March 3, 2000

SUBJECT: Calvert Cliffs Nuclear Power Plant
Unit Nos. 1 & 2; Docket Nos. 50-317 & 50-318
Response to Request for Additional Information Concerning Diesel
Generator 1A Light Load Issue

DIESEL 1A LONG-TERM LOADING

Figure 1

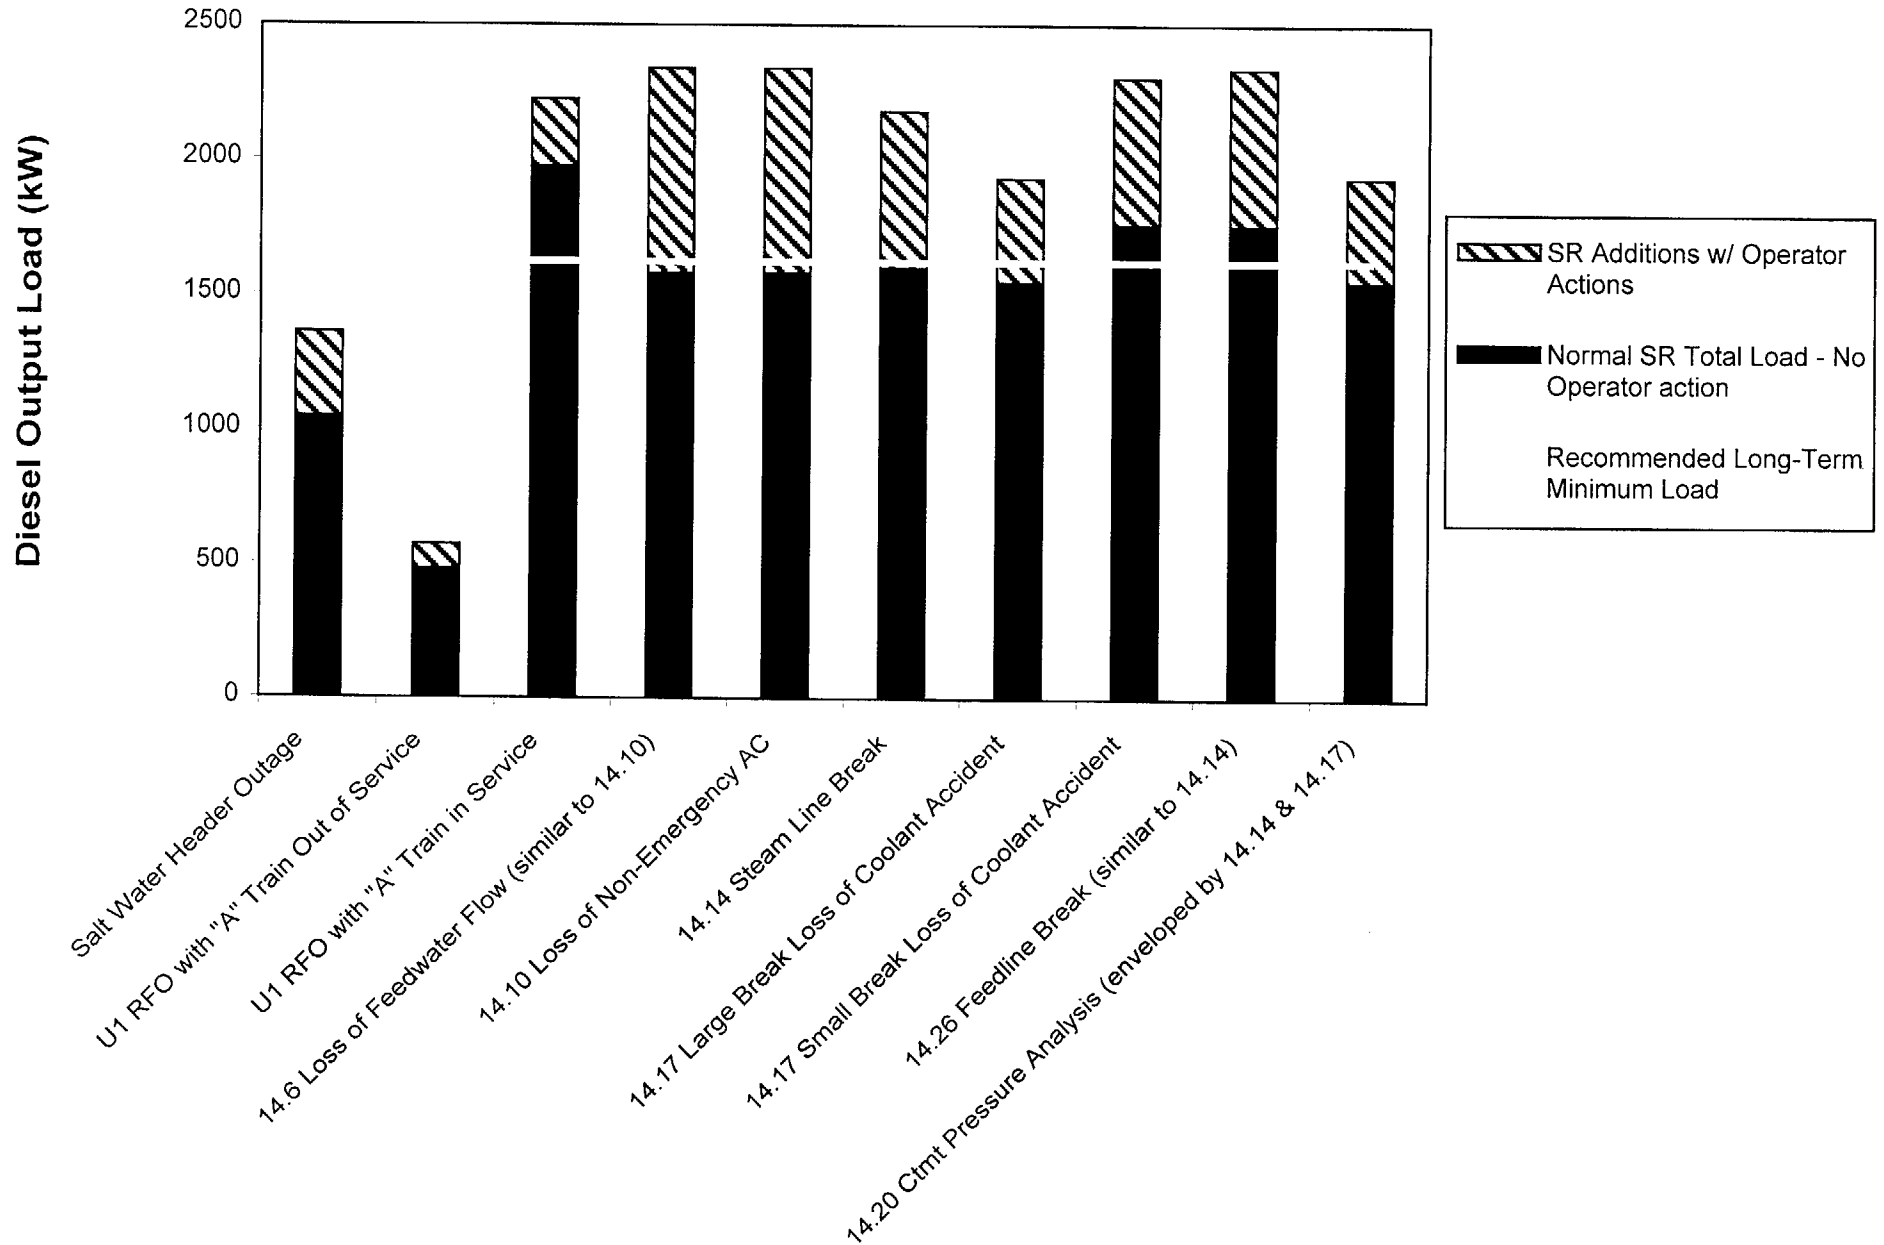
1. *Identify those Chapter 14 scenarios where sufficient safety-related loads would not normally be running to satisfy the minimum load requirement for Diesel Generator (DG) 1A (~ eight hours into the event).*

To evaluate the Updated Final Safety Analysis Report Chapter 14 events, a number of judgments have to be made. Of the 25 operational occurrences, postulated events, and postulated occurrences described in Chapter 14 only six assume a loss of offsite power. Therefore, the evaluation focuses only on these six events. These events are loss of feedwater flow (14.6), loss of non-emergency AC (14.10), steam line break (14.14), large break loss of coolant accident (14.17), small break loss of coolant accident (14.17), feedline break (14.26). As shown in Figure 1, four of the events do not

have sufficient safety-related loads without operator action. Note that the first three items on Figure 1 are not Chapter 14 events.
